Service Bulletin No. 455

MODEL J4500		Field Change Program	section/group 4-Air System & Brakes	Nov. 21, 2017			
SUBJECT	MISCONNECTION OF INSTRUMENT GAUGE AIR LINES						
CONDITIONS

Ref. MCI NHTSA Recall No.: 17V-687

Figure 3. Dual air transducer location.

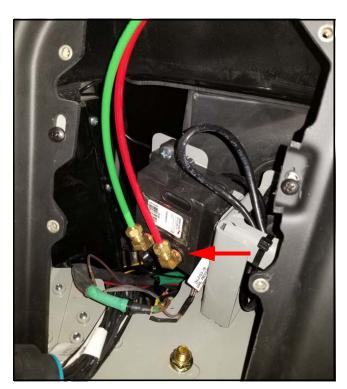
Motor Coach Industries ("MCI") has become aware that the air lines routed from the rear (primary) and front (secondary) air systems to the instrument gauges were misconnected.

As a result of the misconnections, the instrument panel air gauges do not inform the coach operator of the actual air pressure of the primary and secondary air systems. In other words, the rear (primary) gauge would display the air pressure in the front (secondary) air system, and the front (secondary) air system gauge displays the air pressure in the rear (primary) air system.

- Page 3
- 5. Using an allen wrench, remove and retain the six (6) mounting screws from the LH switch panel. Carefully lean the LH switch panel towards the driver's seat to allow access to the interior of the instrument panel.
- 6. Locate the dual air transducer in the cavity behind the LH switch panel mounting plate (refer to Figure 3).
- 7. Locate the 1/4 inch green and red air lines routed and connected to the dual air transducer.
